ADDENDUM NUMBER TWO

PROJECT: Gilham Elementary School Renovation and Expansion Phase 01
TO: Plan Holders and Plan Centers
FROM: GMA Architects
860 West Park Street Suite 300
Eugene, OR 97401
SUBJECT: Changes, Revisions, Clarifications, and Additions
DATE: 02 March 2016

13 SUNSHADE
1 1/2" = 1'-0"

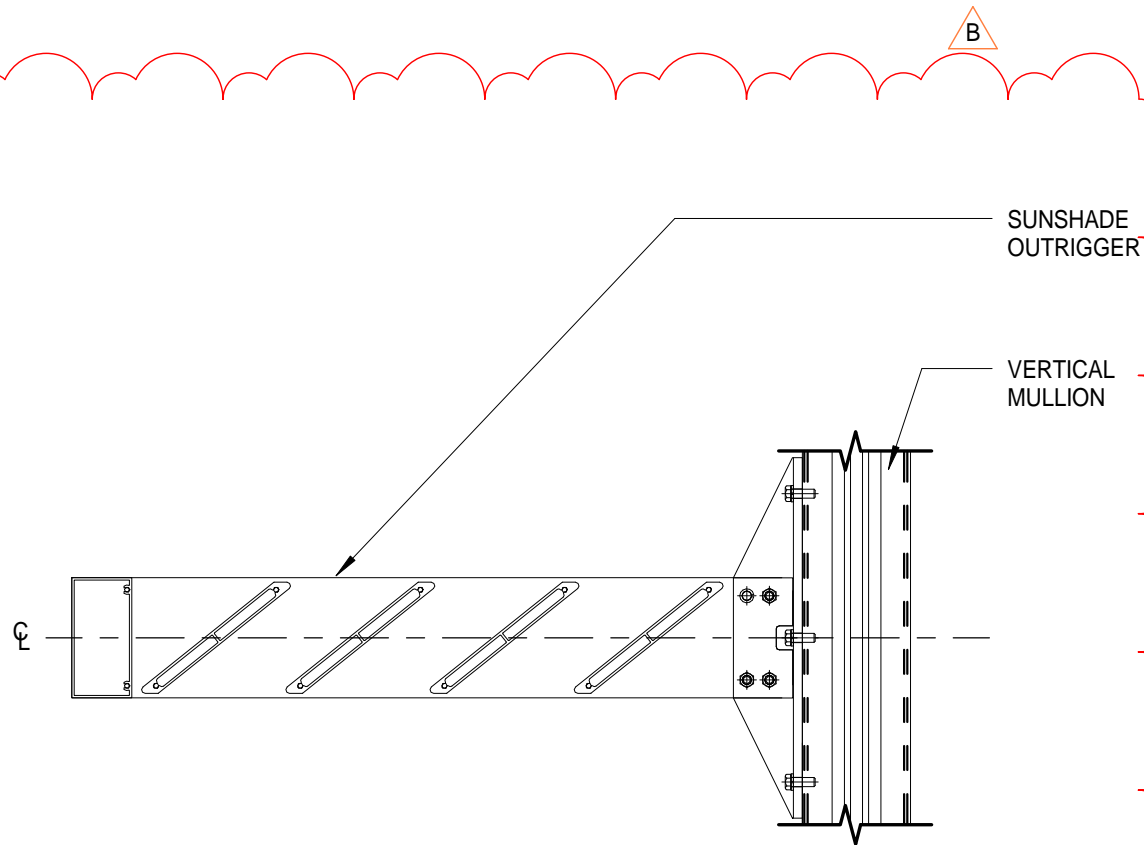
5. Reference Sheet A8.31:

Add: Drawing 13/ADD-2.1, attached.

W10
1/4" = 1'-0"

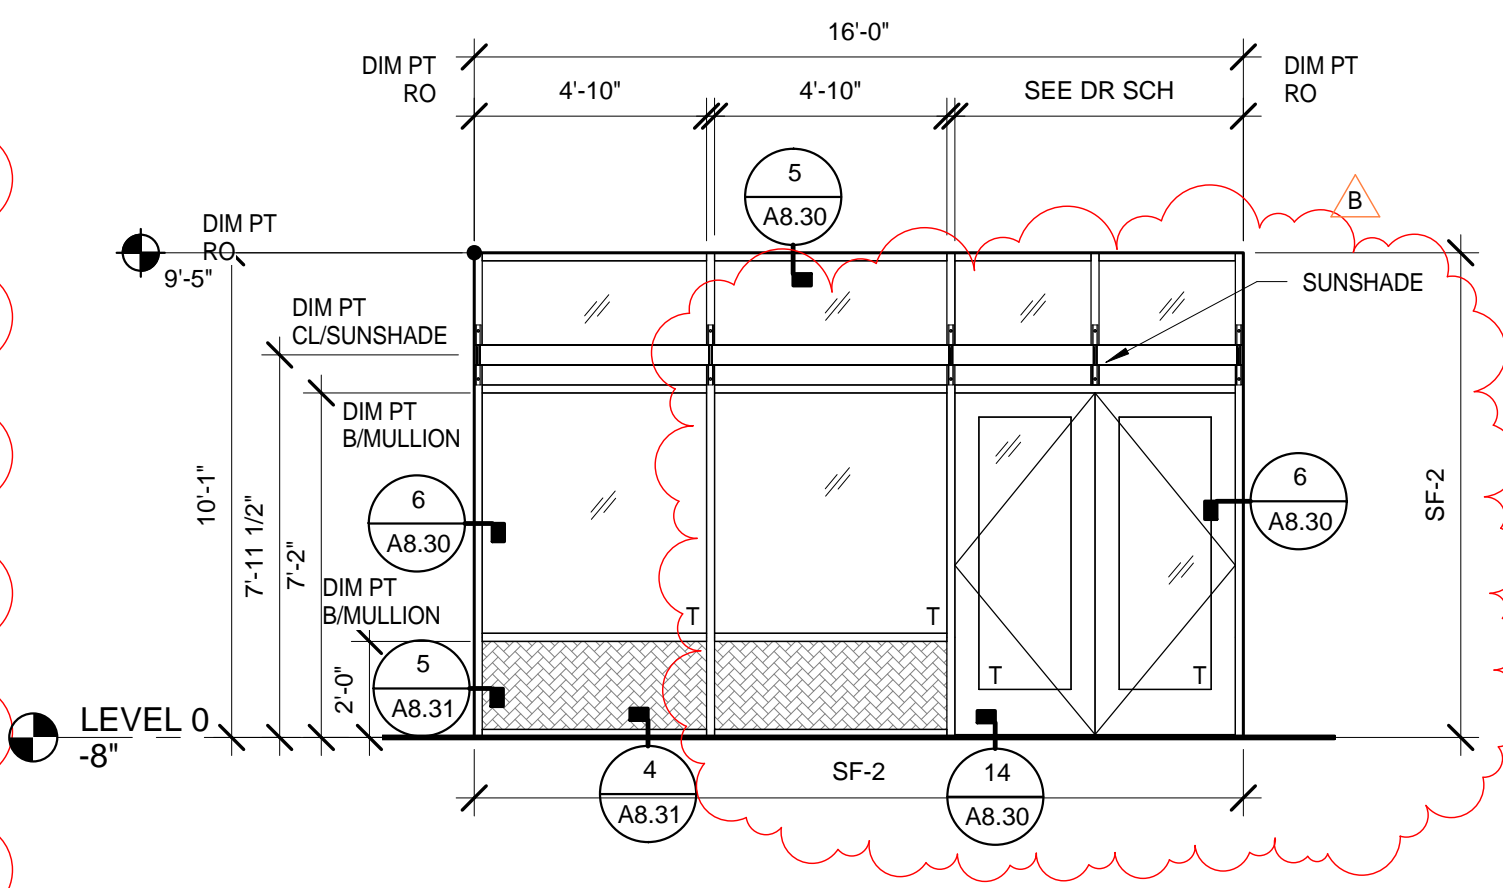
Drawing W10

Delete: Drawing W10.

Add: Revised Drawing W10/ADD-2.1, attached. Revisions are clouded.

PARAPET_BRICK

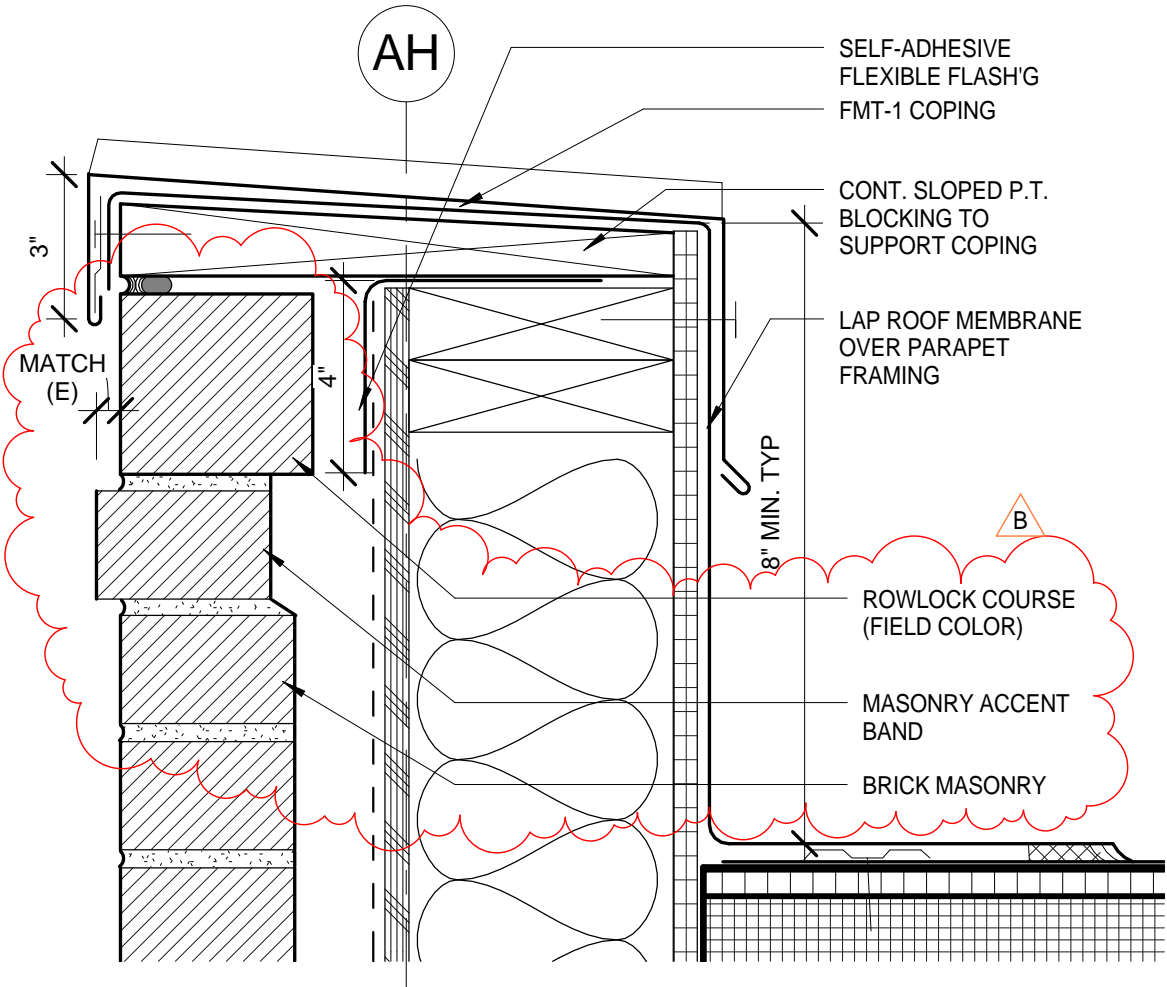
6. Reference Sheet A8.40, Drawing 1:

Delete: Drawing 1.

Add: Revised Drawing 1/ADD-2.2, attached. Revisions are clouded.
